Access Compliance Report

Public Rights-of-Way

Main Street: FAIRHAVEN_AVE Cross Street: YORBA_ST Location: SE

ADA ID: RPRK220126123140 Ramp Type: Type 1 - Perpendicular Diagonal Initial Pass/Fail: Fail Overall Compliance: No Severity Score: 15

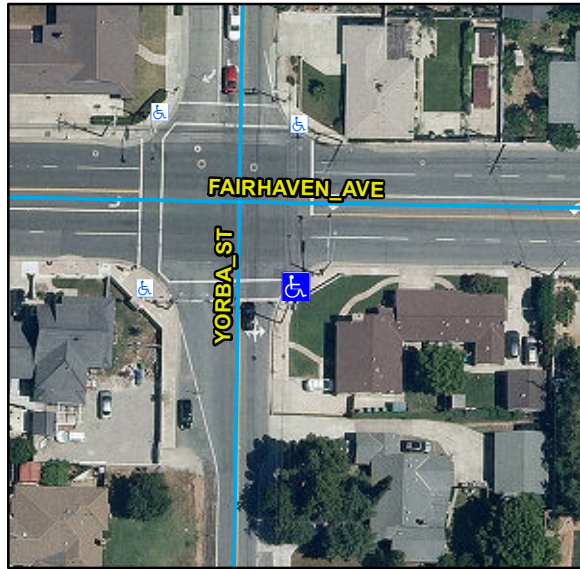
R204.3, R304.2.2, R302.7.2, STD 1115

Remove & Replace Curb Ramp With Two New Directional Ramps or Equivalent. Grind Gutter Lip.
